U.S. Department
of Transportation
**Federal Highway
Administration**

March 6, 1998

In your February 17 letter to Mr. Henry Rentz, you requested Federal Highway Administration's acceptance of the California Department of Transportation Type 70 Bridge Rail at the National Cooperative Highway Research Program (NCHRP) Report 350 test level 4 (TL-4). To support this request, you sent us a copy of your report: "Vehicle Crash Tests of the Type 70 Bridge Rail," dated January 1998, and a copy of a video tape documenting the certification tests that were conducted.

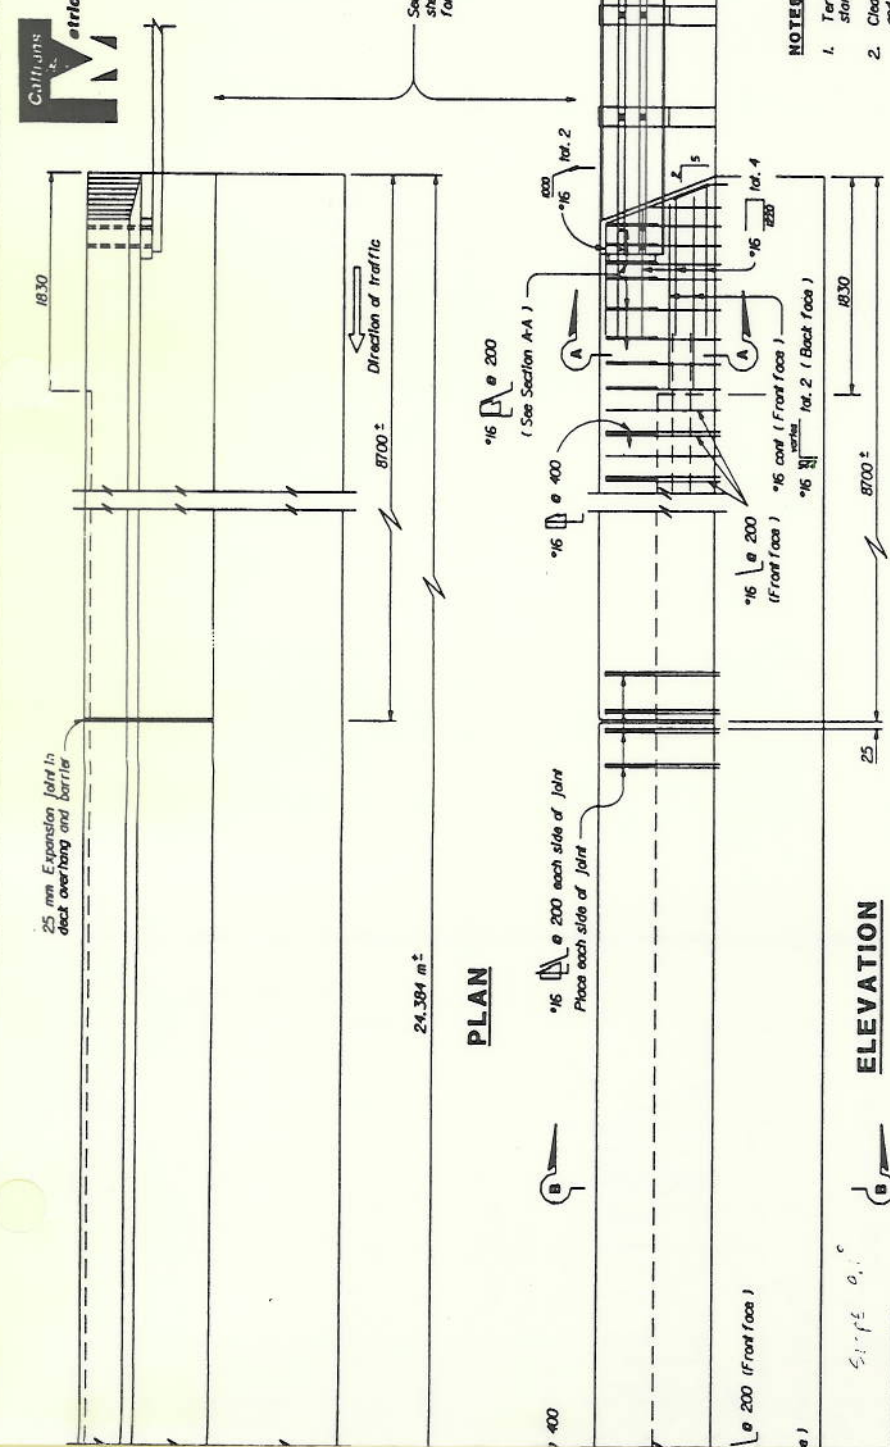
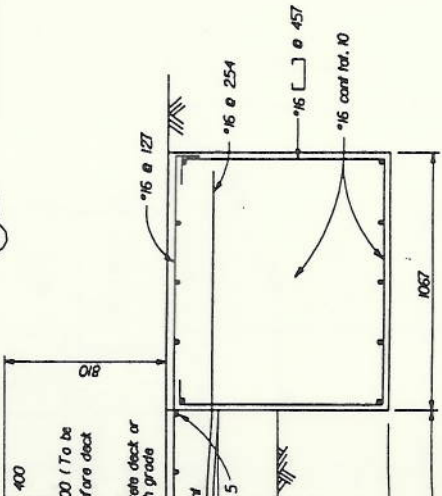
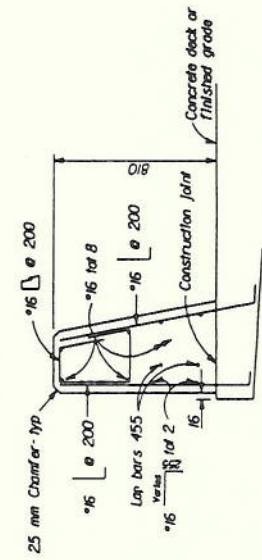
Our review of this material indicated that the Type 70 Bridge Rail is an 810-mm tall concrete barrier with its traffic face sloped at a constant 9.1 degrees away from traffic. This face geometry is identical to your Type 60 roadside/median barrier that was accepted for use on the National Highway System (NHS) at TL-3 in my February 4 letter to you. However, the Type 70 Bridge Rail has a vertical back face with some architectural treatment and is more heavily reinforced than the Type 60. Design details are shown in Enclosure 1.

Figure 2.22 - Test 512 Data Summary Sheet

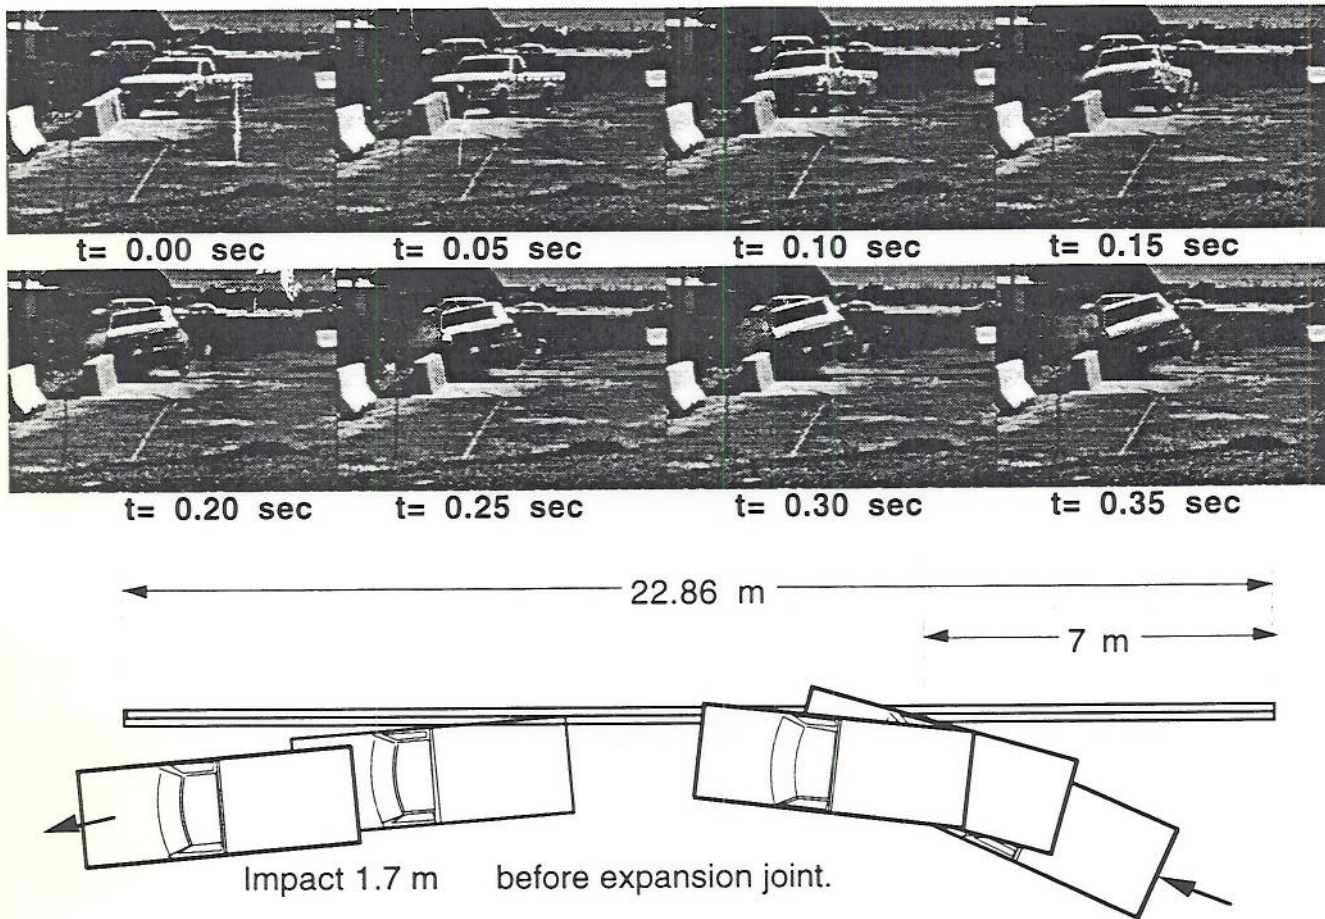
We noted that three tests were reported, including test 4-12 with an 8000 kg single-unit truck impacting the barrier at an angle of 15 degrees and a speed of 80 km/h. Each of these tests met appropriate NCHRP Report 350 evaluation criteria. The individual test results are summarized in Enclosure 2. We noted also that test 4-11 was re-run after a first unsuccessful attempt in which the pickup truck rolled over after impact. You theorized that the non-standard floating rear hub of the test vehicle caused the drive shaft to pull out of the transmission housing on impact and that the shaft then dug into the test track and precipitated the rollover. This test was then re-run with a pickup truck with a standard wheel hub. Considering the successful retest and the earlier pickup truck tests with your Type 60 constant slope barrier as well as successful pickup tests with the New Jersey, F-profile, and the Texas Department of Transportation constant slope barrier, we are willing to consider test 512 (NCHRP Report 350 test 4-11) as an anomaly.
